CITY of NOVI CITY COUNCIL

Agenda Item D October 28, 2013

SUBJECT: Approval of the request of Woods Construction for Homegoods for Preliminary Site Plan and Section 9 façade waiver approval. The subject property is located in Section 15 at 43635 West Oaks Drive in the RC, Regional Center District. The applicant is proposing to modify the entrance to the existing Homegoods store.

FACADE REVIEW

NORTH ELEVATION 1/8" = 1'-0"

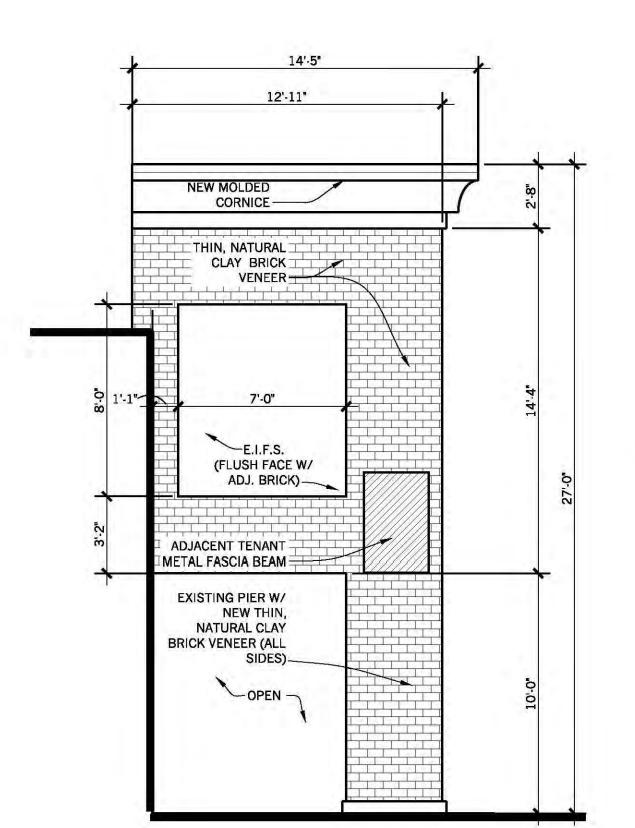
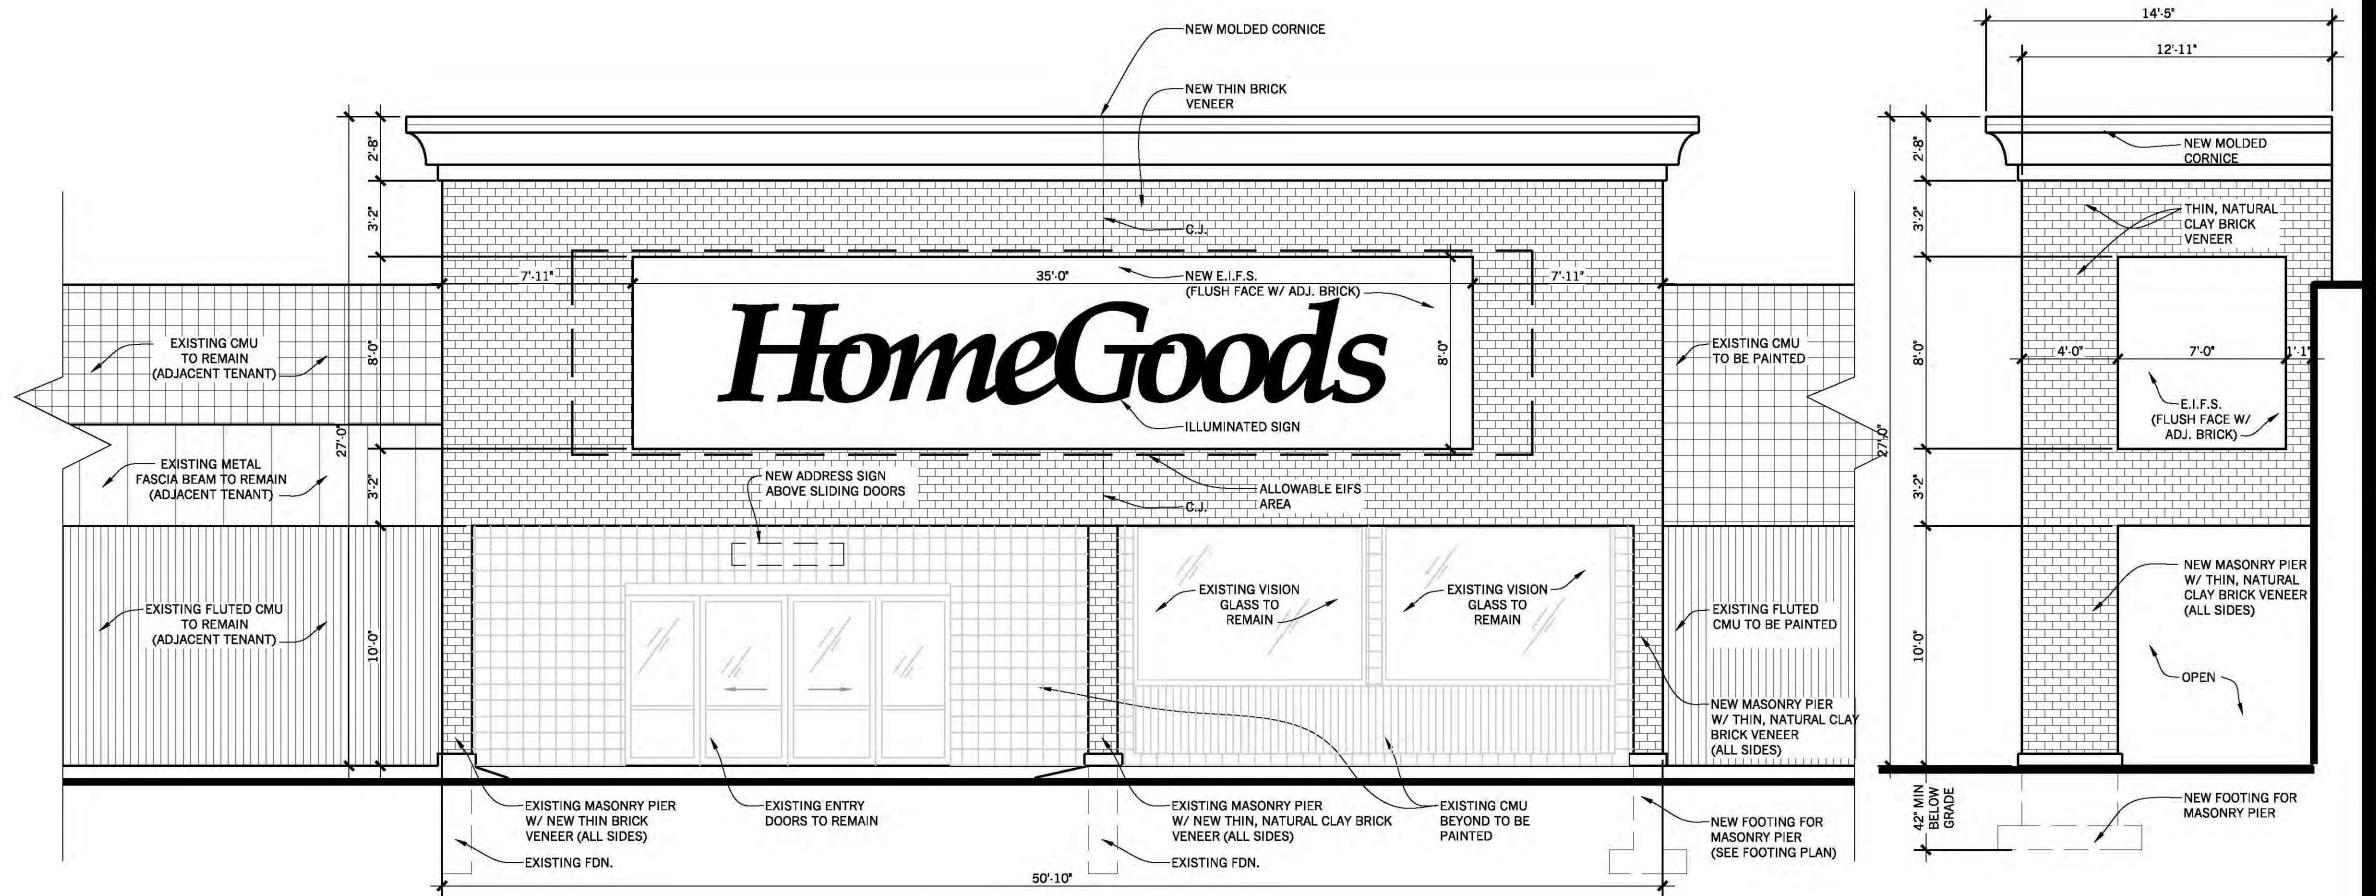
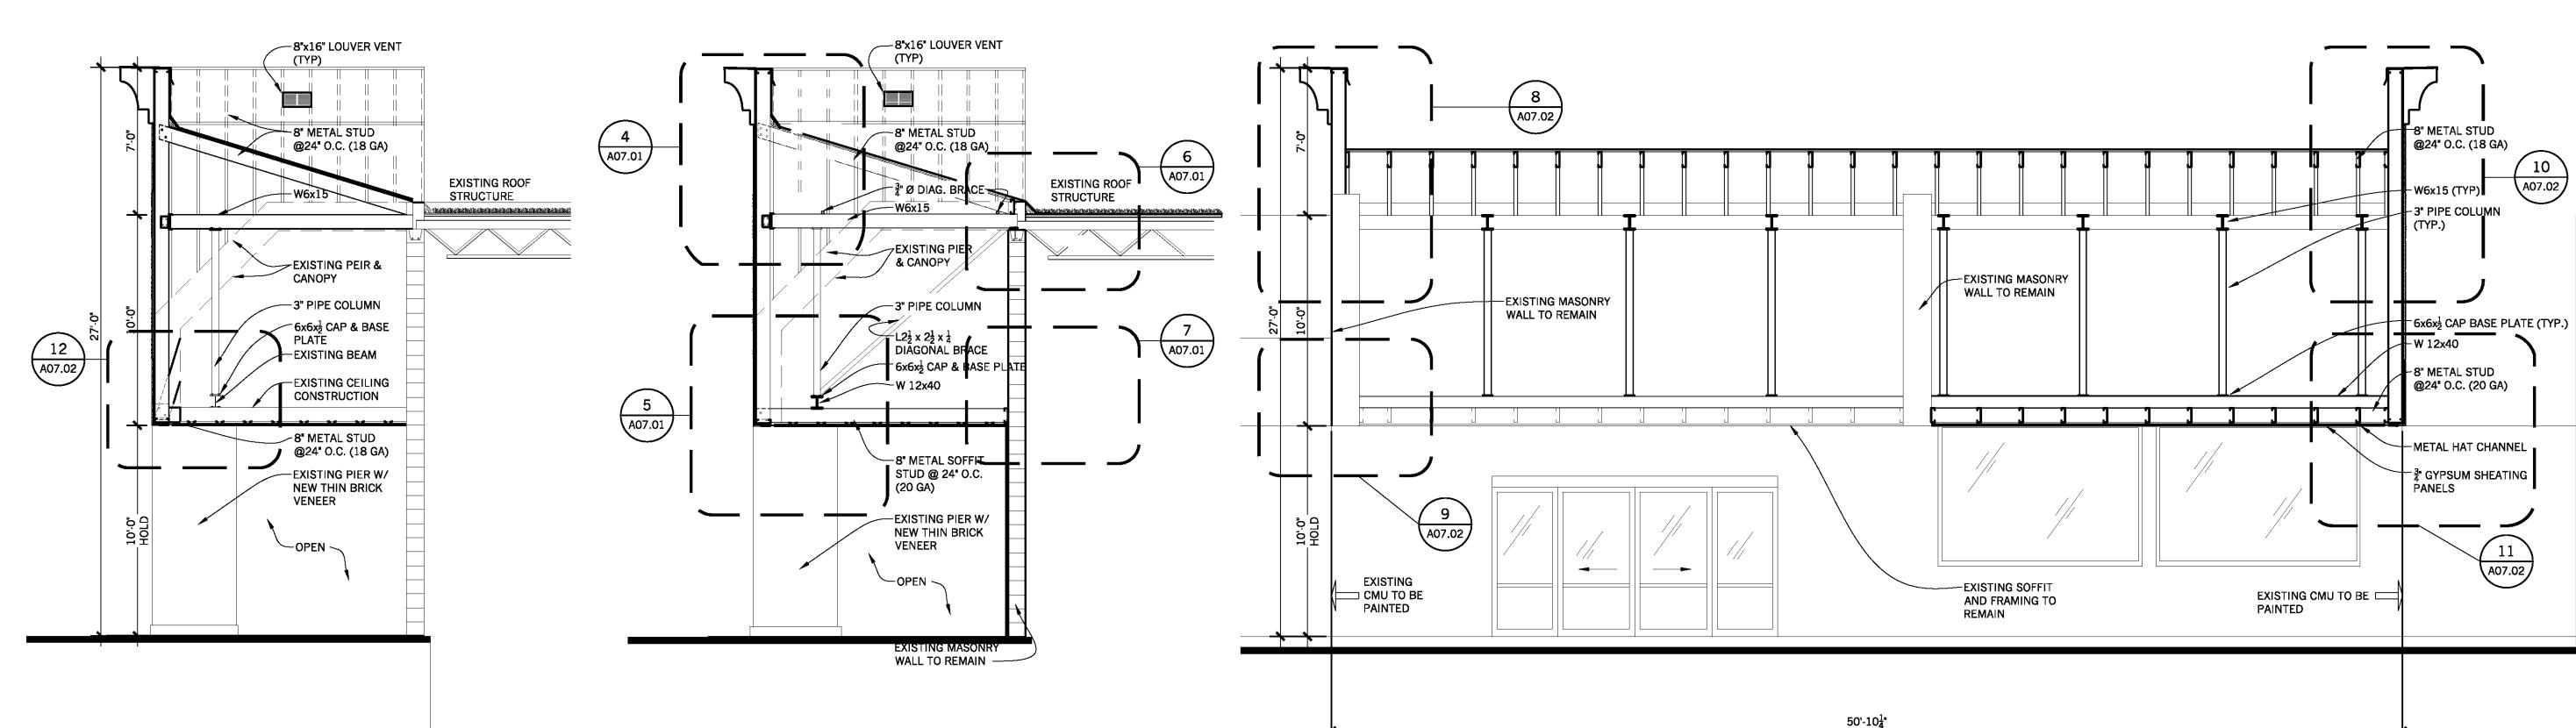
| Façade Region 1 | Front (North) | West | t East | South | Ordinance Maximum |
|--------------------------------------|------------------|------|--------|-------|----------------------|
| Brick, natural clay (4") | 0% | 0% | 0% | NA | 100% (30% Min) |
| Thin Brick Veneer (AKA Panel Brick) | 7% | 85% | 85% | NA | 0% |
| Scored CMU (existing, to be painted) | 37% | 0% | 0% | NA | 0% |
| Fluted CMU (existing, to be painted) | 41% | 0% | 0% | NA | 10% |

As shown above the minimum percentage of Natural Clay Brick is not provided and the proposed percentage of Thin Brick exceeds the maximum amount allowed by the Façade Chart. The percentages of existing Scored CMU and Fluted CMU, which are proposed to be painted, also exceed the maximum amounts allowed by the Façade Chart. These deviations from the Façade Ordinance would require a Section 9 Waiver.

It is strongly recommended that in lieu of painting portions of the façade, the applicant consider re-facing that area with a continuation of the materials introduced on the entrance portico (Thin Brick). This would achieve a significantly greater degree of compatibility with adjacent buildings and enhance the appearance of the overall shopping center.

The applicant should provide a color sample board showing the colors of all proposed materials.

Recommendation – The proposed alteration generally represents an improvement in the existing façade that, to some extent, will increase compatibility with adjacent buildings. A Section 9 Waiver is therefore recommended for the underage of Natural Clay Brick and overage of Thin Brick and painted CMU. This recommendation is contingent upon the applicant providing a sample board indicating carefully coordinated colors that are harmonious with adjacent buildings at least 5 days prior to the Planning Commission meeting.
